**APPLICATION
 FOR PERCOLATION TESTING AND SITE EVALUATION**

**APPLICATION FOR VARIANCE
 TO COMAR ONSITE WATER/SEWER FOR MDE APPROVAL**

Re: **Percolation Test Report**
14511 MacClintock Ct.
Glenwood, MD 21738

WARFIELD ESTATES, S-4, BL-A
 14511 MACCLINTOCK CT. - LOT 21
 TAX MAP: 21 - GRID: 04 - PARCEL: 129
 FOURTH ELECTION DISTRICT - HOWARD COUNTY, MARYLAND
PERCOLATION CERTIFICATION PLAN

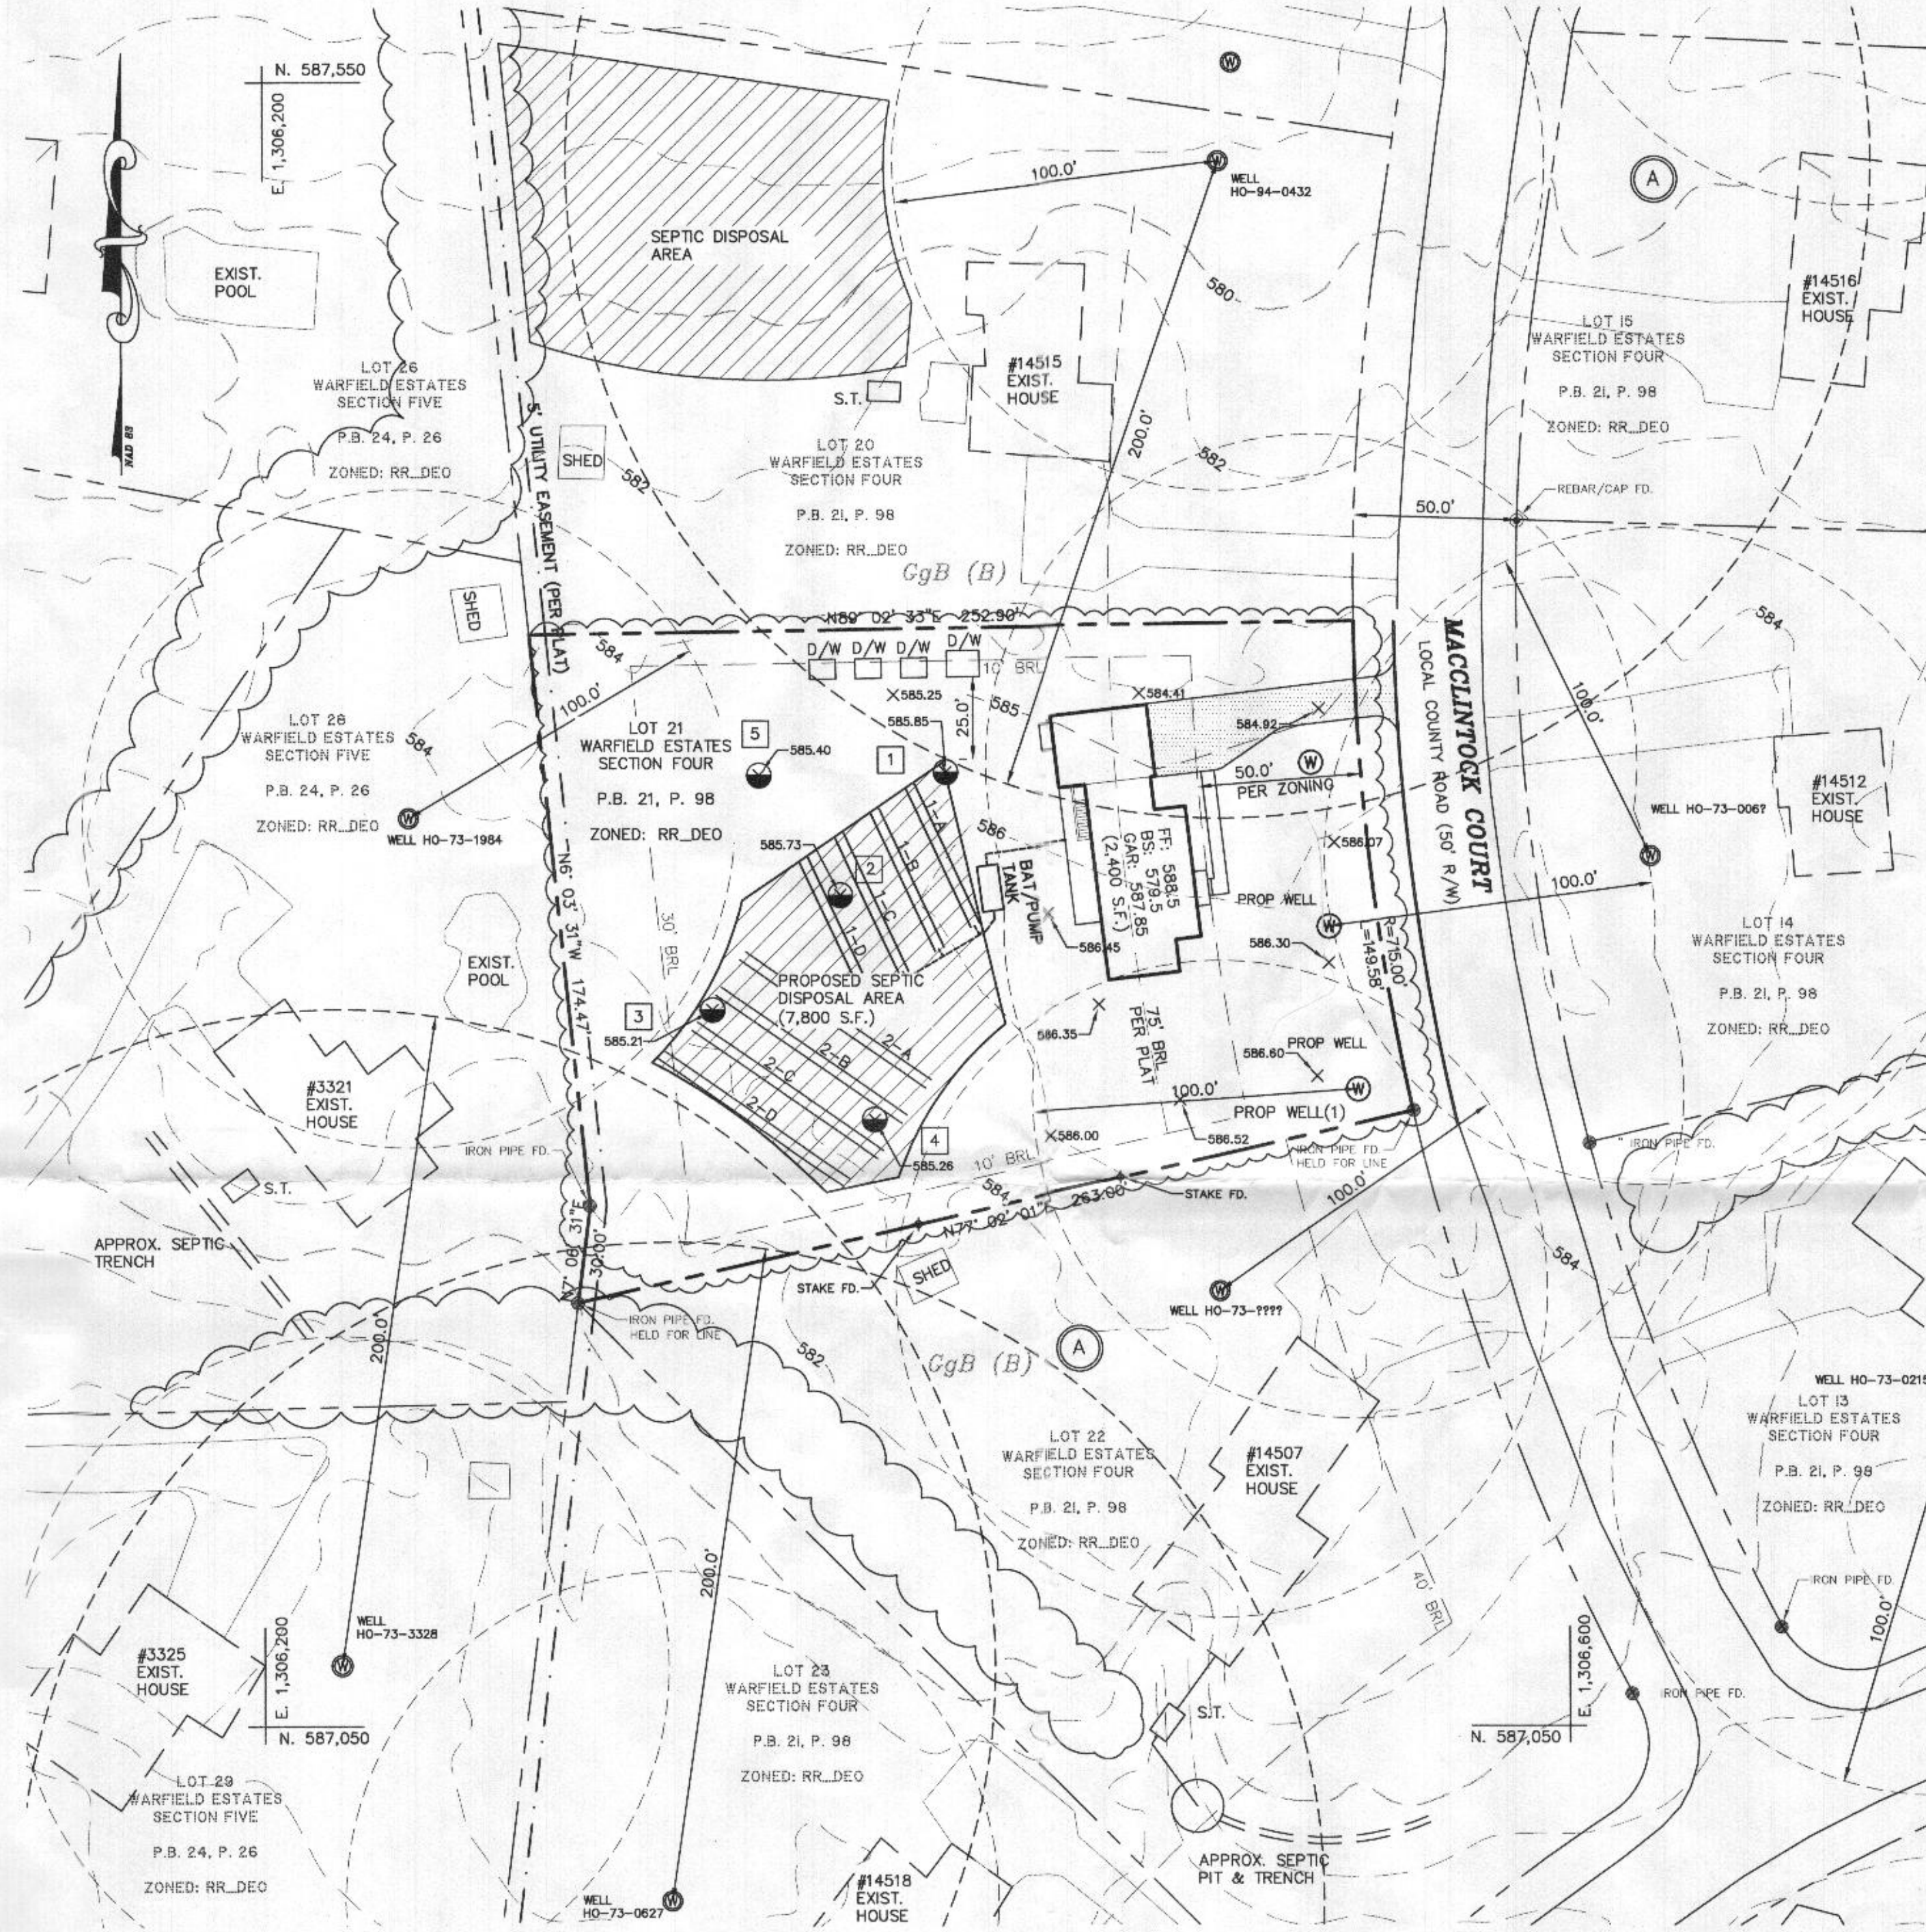
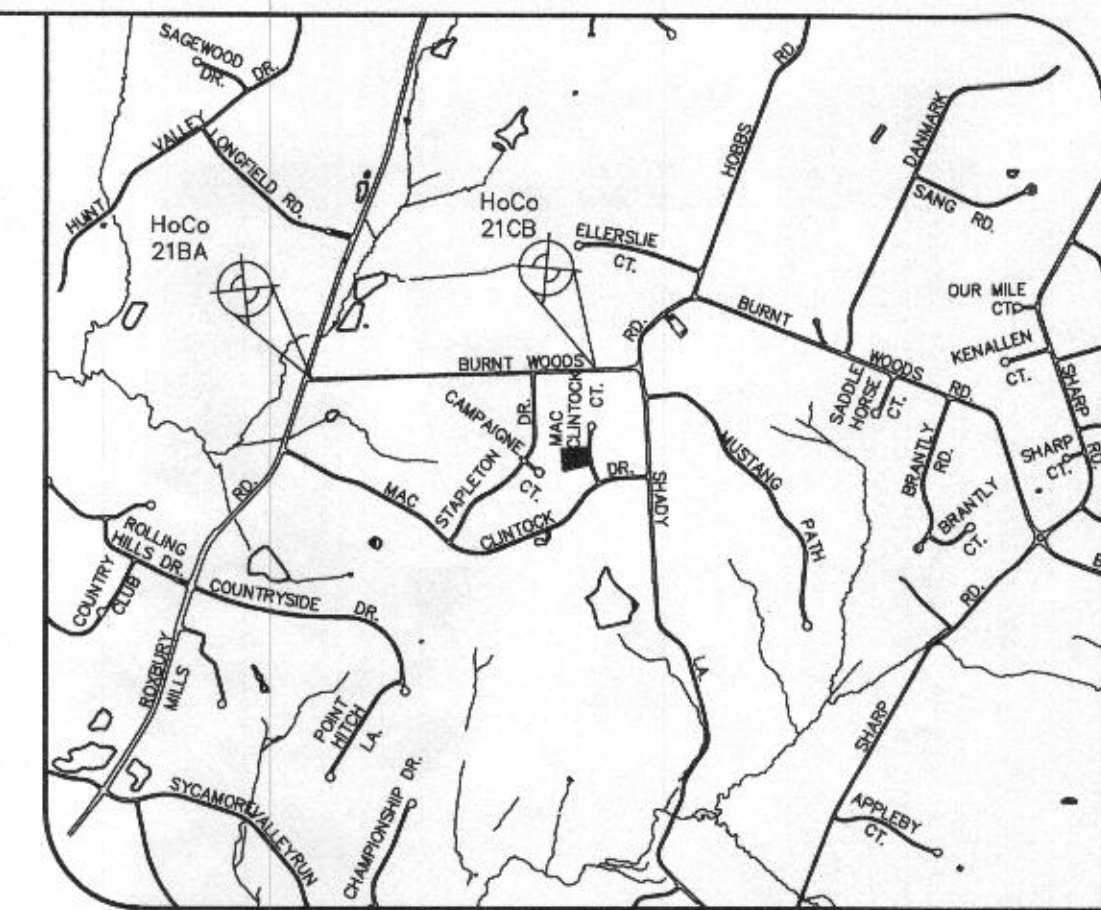
I spoke with the MDE regional and we agree that based on the perc test notes, the appropriate specs should be:

1st system: 0.6 rate with effective area starting at 5.5' and trench bottom at 8'

2nd system: 0.6 rate with effective area starting at 7' with bottom at 8'

We appreciate you efforts on this. The number just don't add up with the 6'.

SYSTEM	APPLICATION RATE (GPD / SF)	MAXIMUM FLOW RATE (GPD)	AREA OF REQUIRED TRENCH (SF)	TRENCH WIDTH (FT)	LENGTH OF REQUIRED TRENCH (LF)	EFFECTIVE DEPTH BEGINS (FT)	TRENCH BOTTOM DEPTH (FT)	TRENCH REDUCTION**	ADJUSTED LENGTH OF REQUIRED TRENCH (LF)	MINIMUM TRENCH SPACING (FT)	NUMBER OF TRENCHES	REQUIRED TRENCH LENGTH (FT)
INITIAL	0.6	600	1,000	3	333.3	9.5	8.0	0.55	183.3	10.0'	4	46'
REPLACEMENT	0.6	600	1,000	3	333.3	7.0	8.0	0.83	276.7	10.0'	4	70'

WARFIELD ESTATES, S-4, BL-A
 14511 McCLINTOCK CT. - LOT 21
 TAX MAP: 21 - GRID: 04 - PARCEL: 129
 FOURTH ELECTION DISTRICT - HOWARD COUNTY, MARYLAND
PERCOLATION CERTIFICATION PLAN

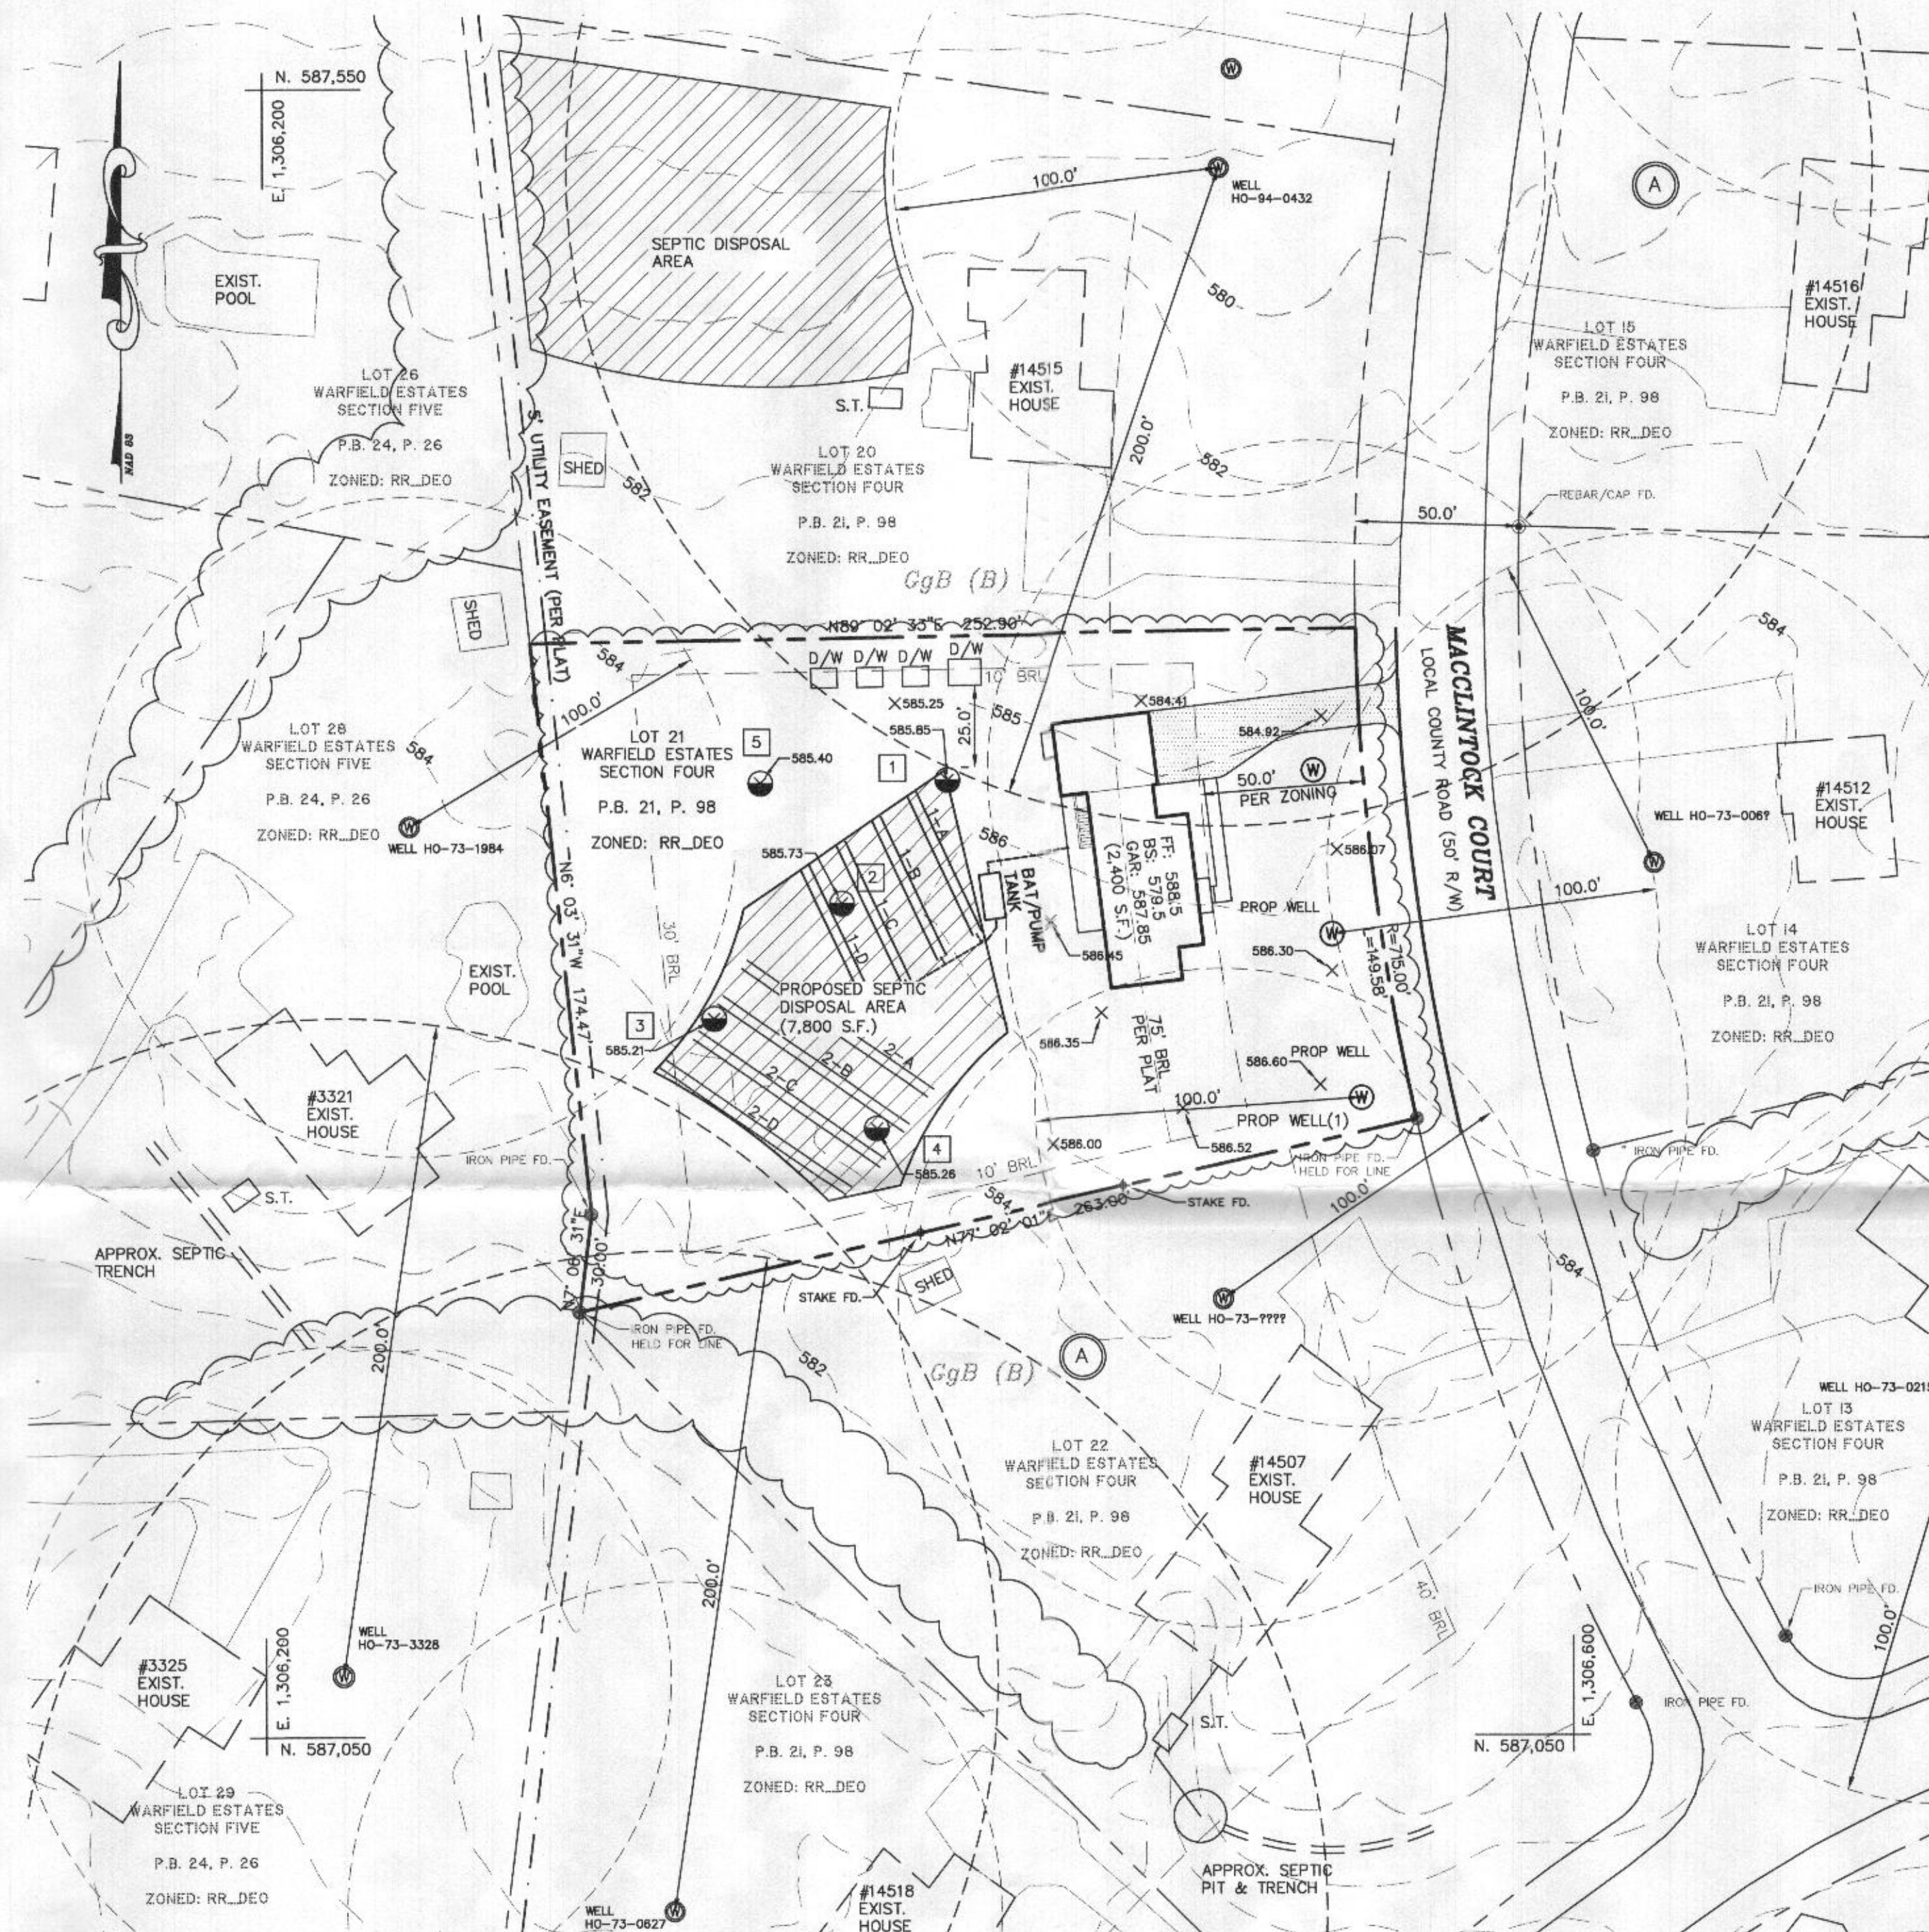
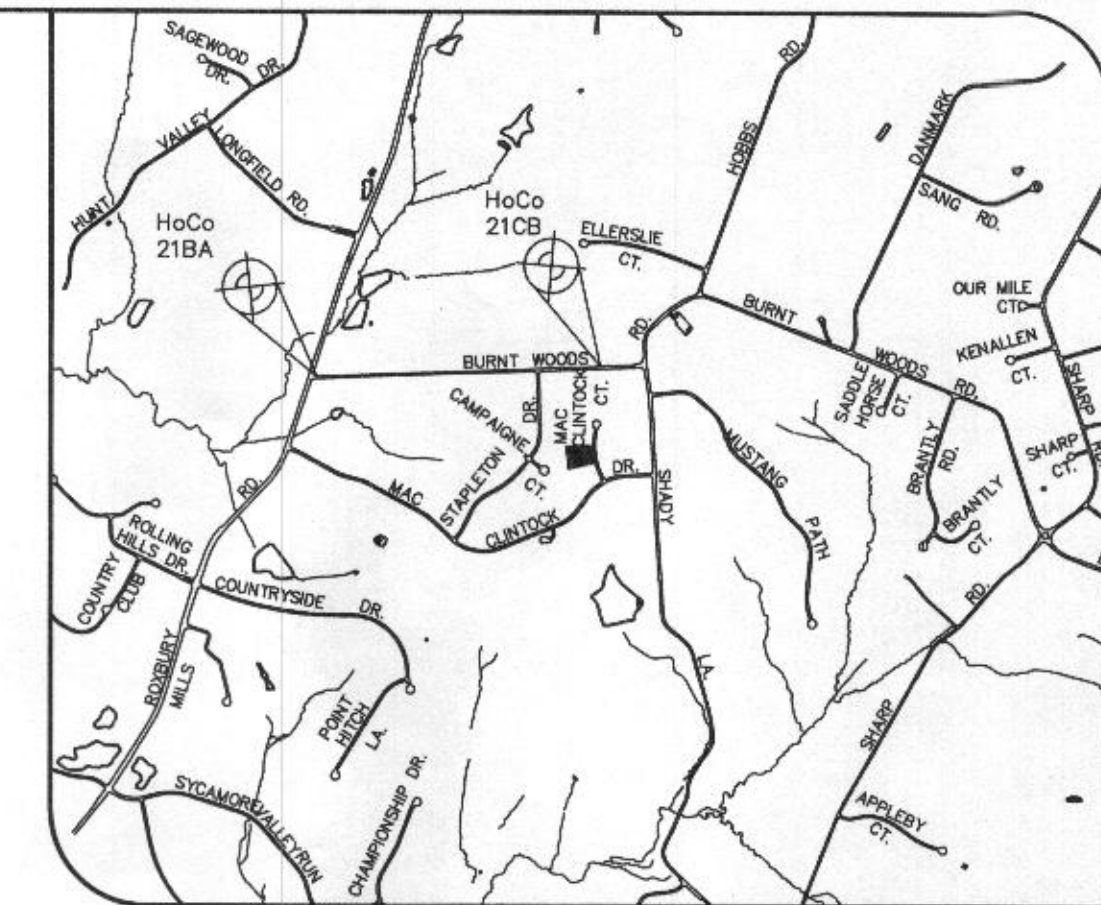
- THE MARYLAND DEPARTMENT OF THE ENVIRONMENT HAS REVIEWED THE PROPOSED WELL AND SEWAGE DISPOSAL AREA LOCATION ILLUSTRATED ON THE PLAN AS RECOMMENDED BY THE HOWARD COUNTY HEALTH DEPARTMENT, AND HAS GRANTED A VARIANCE TO ALLOW THE SEWAGE DISPOSAL AREA LOCATION ON WARFIELD ESTATES LOT 21 TO BE ABOVE GRADE OF WARFIELD ESTATES LOTS 23 & 29 PURSUANT TO THE FOLLOWING:

- A BAT+LPD UNIT MUST BE INSTALLED IN THE INITIAL & REPLACEMENT SYSTEM.
 - ALL DRAINFIELDS INSTALLED IN THE RESPECTIVE SDA WILL BE DESIGNED FOR LOW-PRESSURE DISTRIBUTION OR EQUIVALENT.

SYSTEM	APPLICATION RATE (GPD / SF)	MAXIMUM FLOW RATE (GPD)	AREA OF REQUIRED TRENCH (SF)	TRENCH WIDTH (FT)	LENGTH OF REQUIRED TRENCH (LF)	EFFECTIVE DEPTH BEGINS (FT)	TRENCH BOTTOM DEPTH (FT)	TRENCH REDUCTION FACTOR**	ADJUSTED LENGTH OF REQUIRED TRENCH (LF)	MINIMUM TRENCH SPACING (FT)	NUMBER OF TRENCHES	REQUIRED TRENCH LENGTH (FT)
INITIAL	0.6	600	1,000	3	333.3	5.5	8.0	0.55	183.3	10.0'	4	46'
REPLACEMENT	0.6	600	1,000	3	333.3	7.0	8.0	0.83	276.7	10.0'	4	70'
